## ***Interactive comment on “Auto-control of pumping operations in sewerage systems by rule-based fuzzy neural networks” by Y.-M. Chiang et al.***

**Y.-M. Chiang et al.**

Interactive comment on Hydrol. Earth Syst. Sci. Discuss., 7, 6725, 2010.

Fig. 1. revised Figure 3

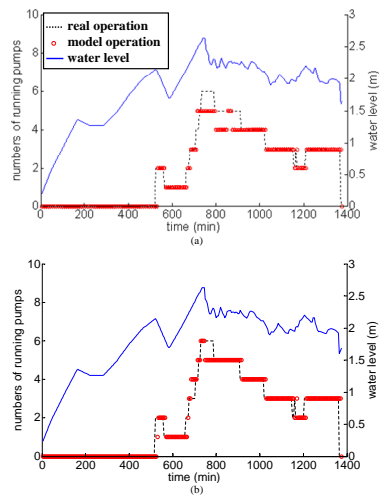
g) Figure 3. Please, add water level to the legend. Reply: Thanks! “water level” has been added to the legend.
